SUBJECT: ARKANSAS NUCLEAR ONE, UNIT 2 (ANO-2) - RELAXATION REQUEST  
FROM U.S. NUCLEAR REGULATORY COMMISSION (NRC)  
ORDER EA-03-009 FOR THE CONTROL ELEMENT DRIVE MECHANISM  
(CEDM) NOZZLES (TAC NO. MC8282)

SAFETY EVALUATION BY THE OFFICE OF NUCLEAR REACTOR REGULATION  
RELAXATION REQUEST FROM ORDER (EA-03-009)  
ESTABLISHING INTERIM INSPECTION REQUIREMENTS FOR  
REACTOR PRESSURE VESSEL HEADS AT PRESSURIZED WATER REACTORS  
ARKANSAS NUCLEAR ONE UNIT 2  
DOCKET NUMBER 50-368

Figure 1

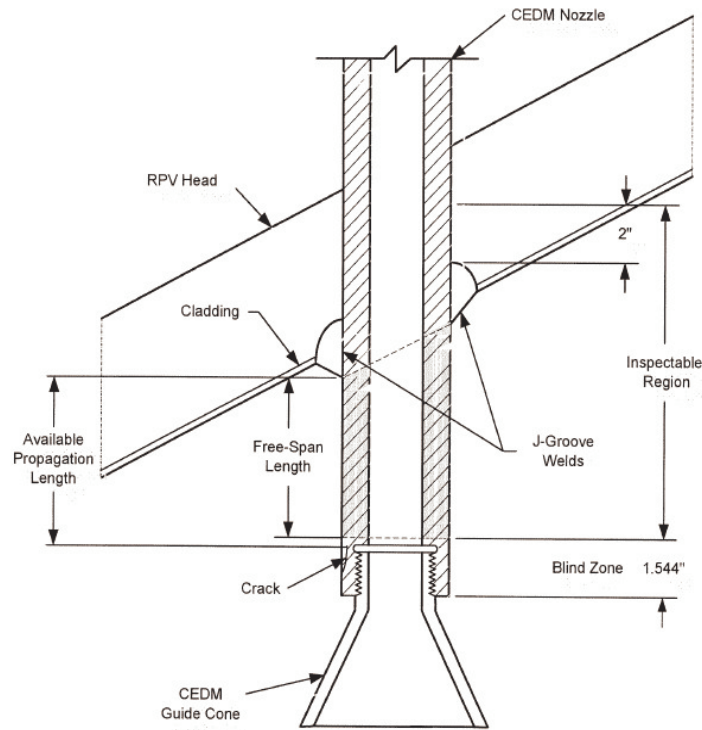
The licensee states that the ID of each control element drive mechanism (CEDM) nozzle (i.e., nozzle base material) shall be UT examined from 2 inches above the root of the J-weld (on a horizontal plane perpendicular to the nozzle axis) to 1.544 inches above the bottom of the nozzle. The licensee will also perform an assessment to determine if leakage has occurred into the interference fit zone, as currently specified in Section IV.C.(5)(b)(i) of the Order. Figure 1 of this safety evaluation (SE) is from the licensee's submittal and shows the inspection areas of a CEDM nozzle as defined by the licensee.

The licensee states that the guide cones are attached to the bottom of the ANO-2 CEDM nozzles via threaded connections. The guide cones screw into the end of the CEDM nozzles with a welded set screw and two tack welds at the cone-nozzle interface to secure the guide cone to the nozzle. There is a 45E chamfer at the top of the threaded region that is 0.094-inch in length. The length of the threaded region is 1.25 inches.

According to the licensee, meaningful UT data cannot be collected in the threaded area or the chamfer region. The chamfer region geometry causes sporadic signals while, once the guide cone is reached, sound cannot pass into the CEDM nozzle base material because of the gap that exists between the guide cone and the nozzle at the threaded connection. This leaves a length of 1.344 inches ( $1.25 + 0.094$ ) at the bottom of the CEDM nozzle that cannot be inspected by UT examination due to nozzle configuration.

The staff concludes that the licensee's proposed alternative examination of the CEDM RPVH penetration nozzles using UT from 2 inches above the J-groove weld to 1.544 inches above the bottom of the CEDM nozzles, and the augmented examination of nozzles without sufficient free-span length, provide reasonable assurance of the structural integrity of the RPVH, VHP nozzles, and welds. Further inspection of the CEDM nozzles in accordance with Section IV.C.(5)(b) of the Order would result in hardship without a compensating increase in the level of quality and safety. Therefore, pursuant to Section IV, paragraph F of the Order, good cause has been shown for relaxation of the Order, and the staff authorizes, for the remainder of the current third 10-year inservice inspection interval, commencing with the start of the fall 2006 refueling outage, the proposed alternative inspection for all CEDM head penetration nozzles at ANO-2, subject to the following condition as stated in the licensee's submittal dated September 9, 2005:
